August 16, 2023

RE: Remedial Action Work Plan – Addendum #1
737 4th Avenue, Brooklyn, New York
BCP #C224332

SUPPORT OF EXCAVATION FILED UNDER **DOBNOW# B00580365-S2**. FOR SUPPORT OF EXCAVATION FILING, UNDERPINNING SCOPE SHOWN FOR REFERENCE ONLY. FOR UNDERPINNING FILING SEE DOB FILING NUMBER **DOBNOW# B00580365-S6**.

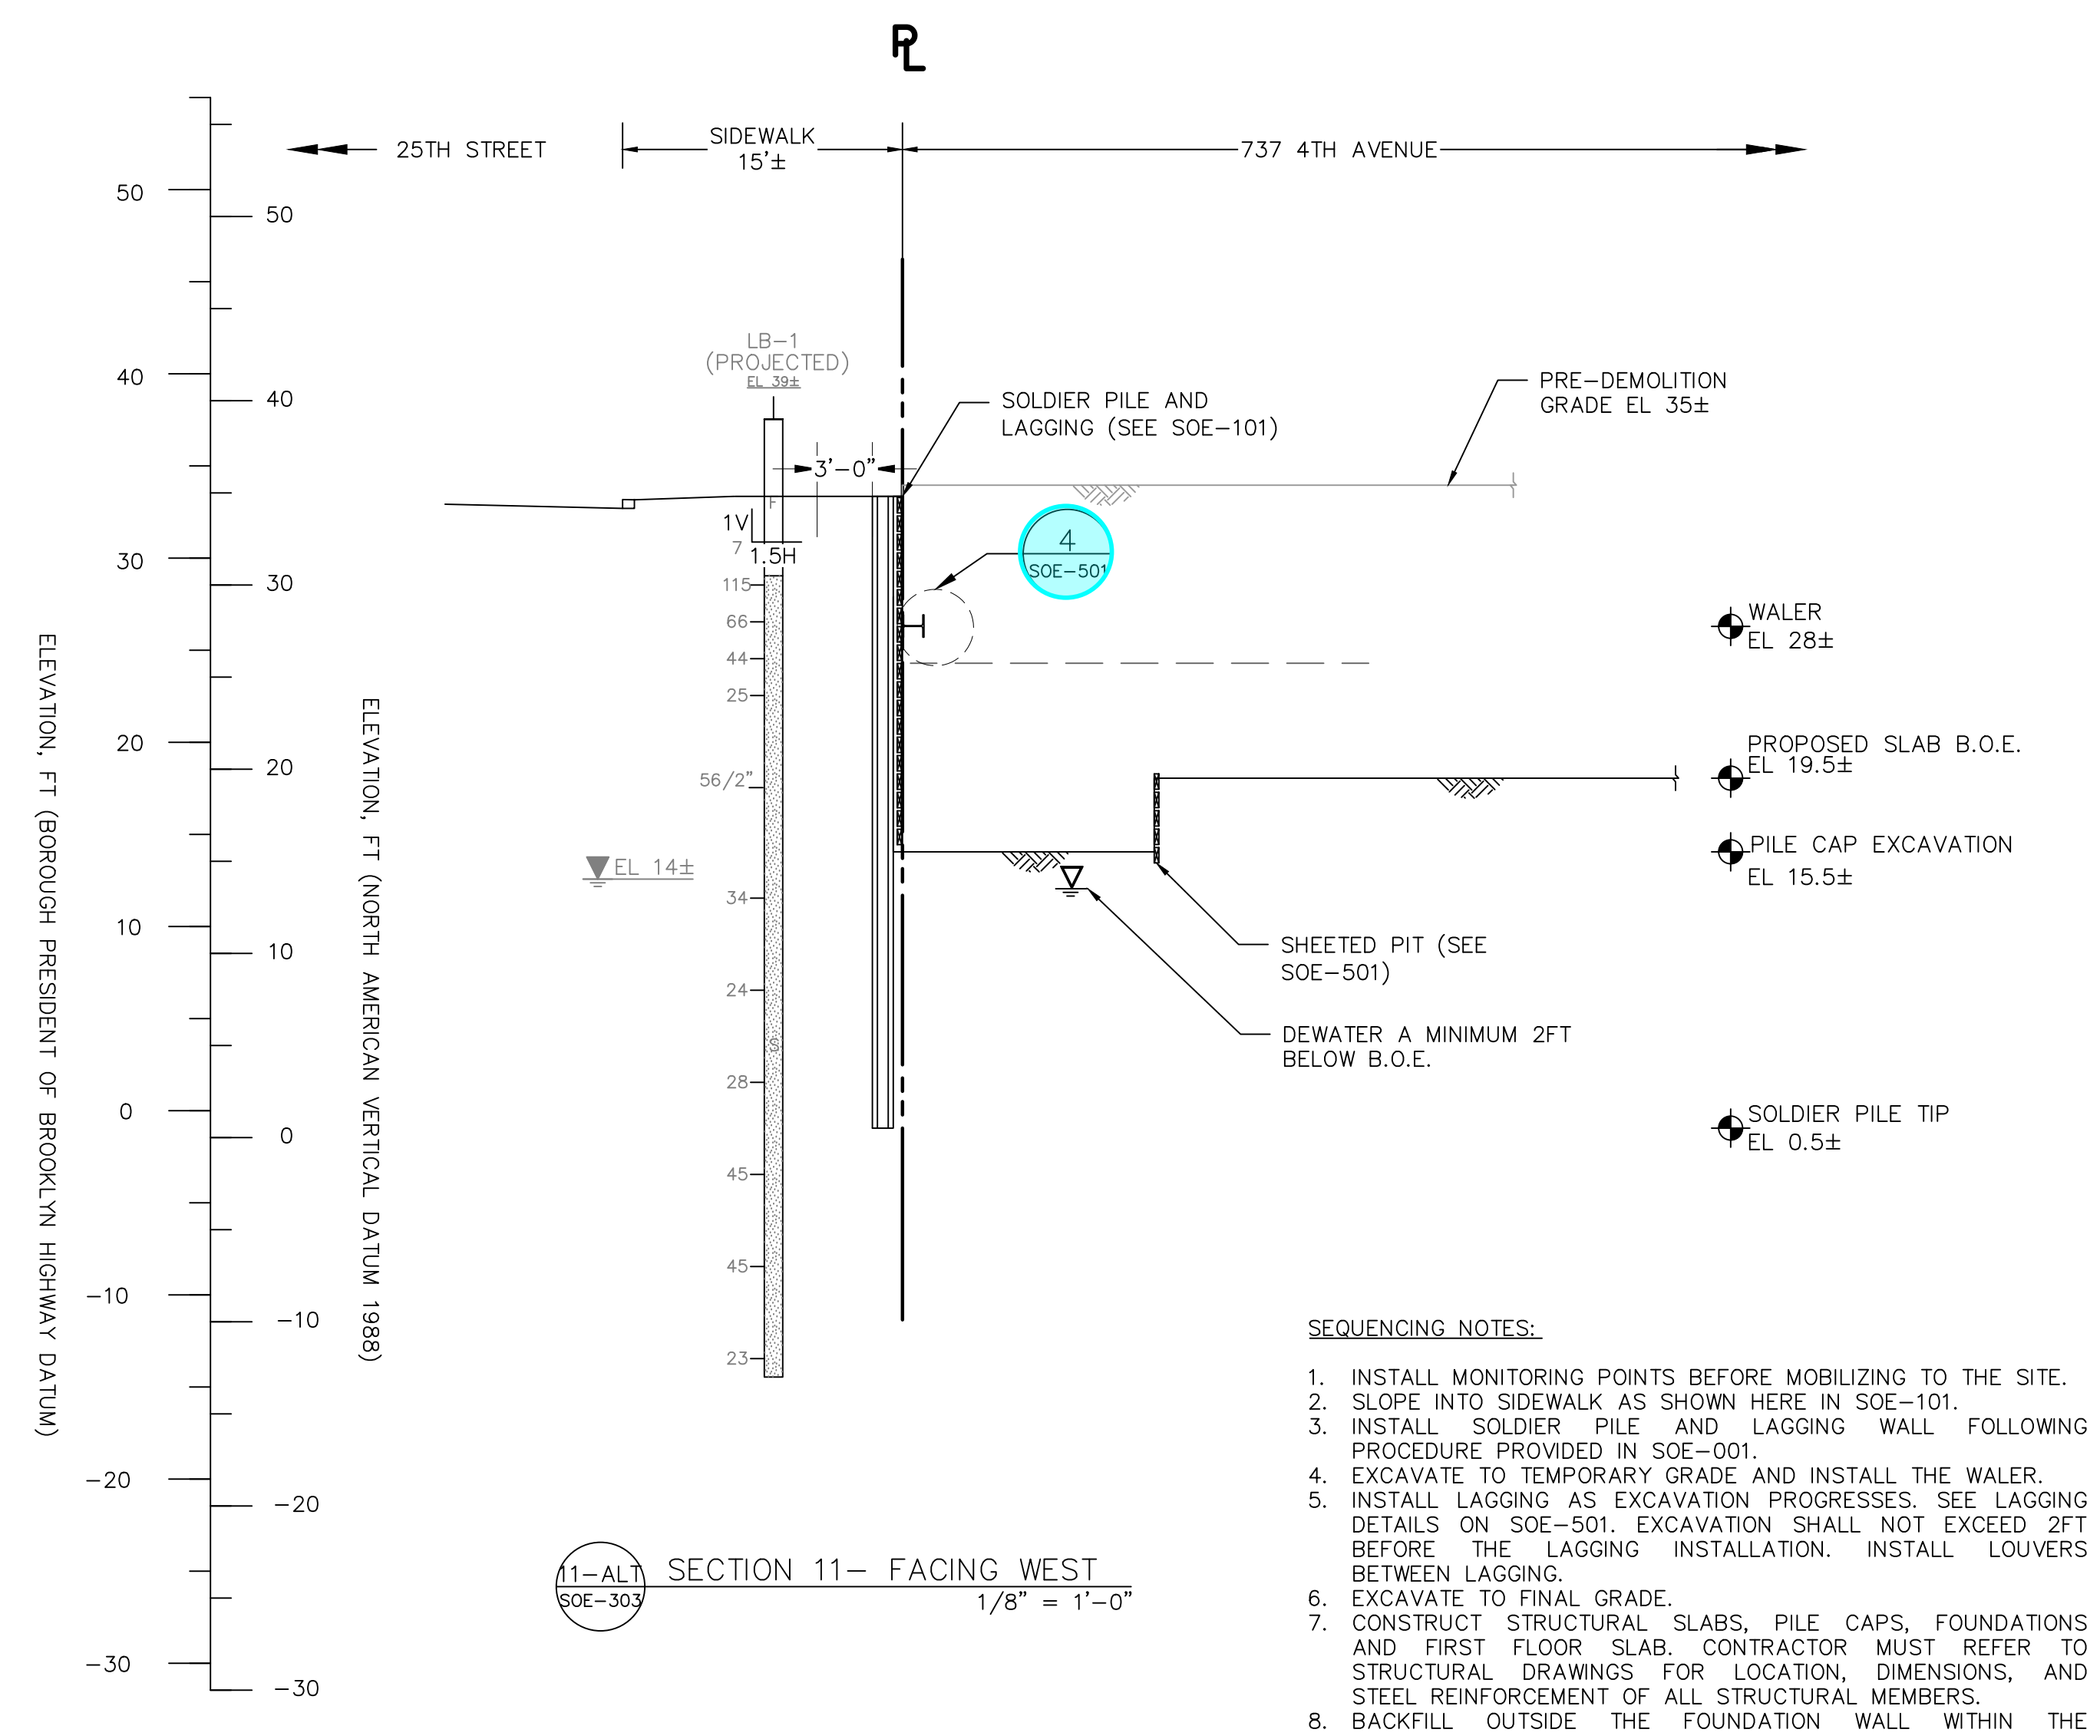
As outlined in the IRM Work Plan, a secant barrier wall is proposed to be installed along the shared property line with 207 25th Street. The secant piles are proposed to be installed to a minimum depth of two feet below the groundwater table elevation (+12) estimated at approximately elevation +14. The proposed design is included in **Attachment 1**.

Based upon the current dewatering model, drawdown is anticipated to elevation +12.5 at the southeast property line. The secant barrier wall depth will be at elevation +12. Based upon this design, any light non-aqueous phase liquid (LNAPL) is anticipated to be contained at the barrier wall and not migrate onto the property.
